Service Information Letter

Units Affected: TDA58 units built from serial number 0914GC0101 (September 2014) through 0217GC0198 (February 2017) (see attached list)

Unit Improvements

Figure 1 — Ground Angle Sensor Placard Location

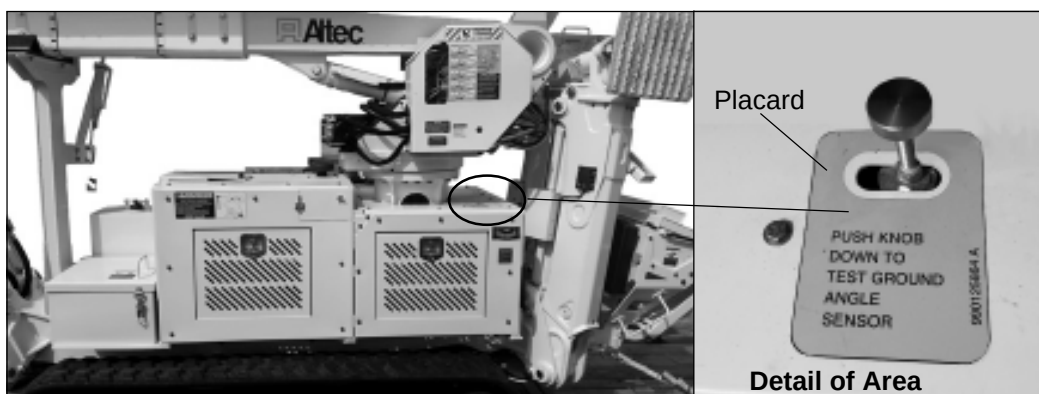
- The slope alert system has been changed to have the tilt sensor signal and high speed track motion lockout activate at a lower angle of tilt. This change will help reduce the possibility of tipping the unit when operating over rougher ground. Look at the top of the carrier on the curbside for the knob and the Ground Angle Sensor Test Placard, part number 990125864 (refer to Figure 1). If that placard is NOT on the unit, order Tilt Sensor Assembly Kit, part number 990141011.

Figure 2 — Ground Angle Sensor Part Number

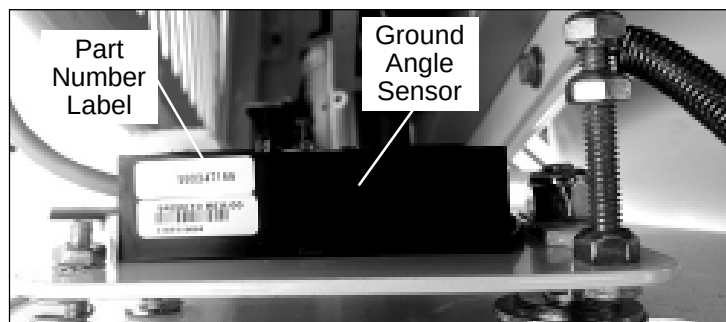
If the knob and the Ground Angle Sensor Test Placard are on the unit, remove the five cap screws holding the cover. Remove the cover and look at the side of the ground angle sensor for the part number (refer to Figure 2). If the sensor part number is not 990347155, order the Tilt Sensor Only Kit, part number 990347155. Reinstall the cover and tighten the cap screws securely.

Figure 3 — Filter Location

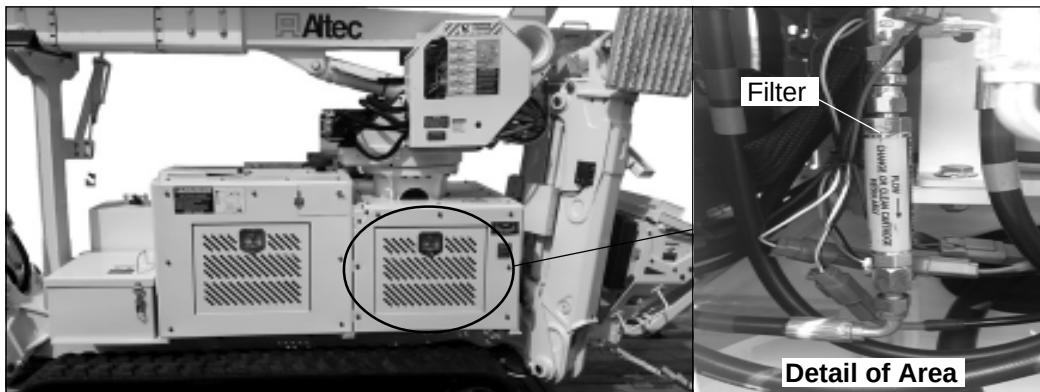
- A filter has been added to the load sense hose to the pump to protect the pump compensator from contamination. It is located behind the curbside hydraulic access door (refer to Figure 3) to the lower left of the valve. It is an in line filter with a yellow label. If it is not in the hydraulic system at that location, order the Load Sense Filter Kit, part number 990377536.

Figure 4 — Manual Override Location and Knob

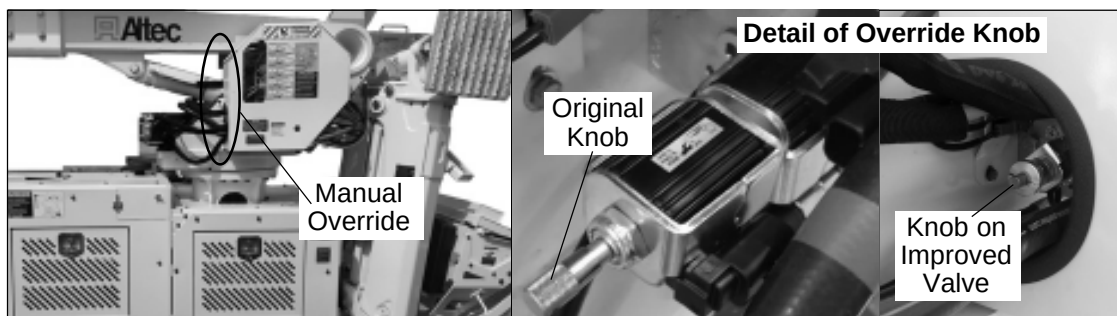
- An improved manual override has been developed to be more reliable in operation. The manual override is located on the left side of the turntable valve cover. The original control has a gold-colored knob (refer to Figure 4). If a gold-colored knob is visible, order the Manual Override Kit, part number 990371943.

Figure 5 — Outrigger Foot Position

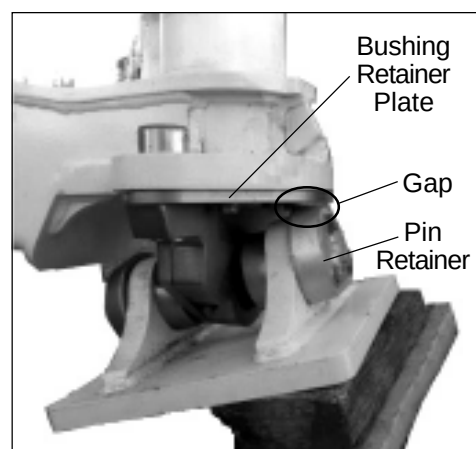
If there is a gap between the outrigger foot pin retainer and the bushing retainer plate (refer to Figure 5) order the Outrigger Shim Kit, part number 990415643. The shims must be added to all outriggers if one has a gap. If any of the kingpins are damaged, order the kingpin assembly, part number 970455213.

Figure 6 — King Pin Inspection

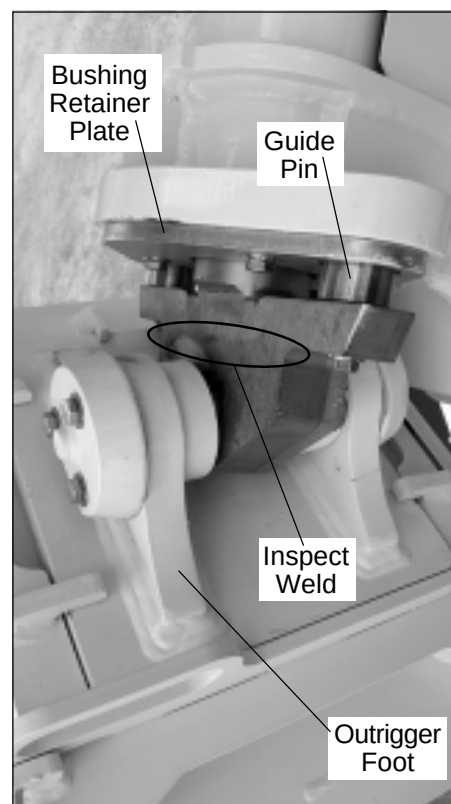
- A shim may need to be added to the outrigger to prevent the swivel outrigger foot from damaging the pins used to mount the outrigger leg to the frame if the outrigger foot bottoms out at an extreme angle. Engage the unit's hydraulic system and extend each outrigger so the outrigger foot presses at an angle on a wheel chock or other angled surface (refer to Figure 5). Look to see if there is any gap between the outrigger foot pin retainer and the bushing retainer plate. If there is a gap, also look at the end of the outrigger foot kingpin assembly to see if it is bent, if the weld is damaged or cracked, or if the assembly is not even on both guide pins (refer to Figure 6).
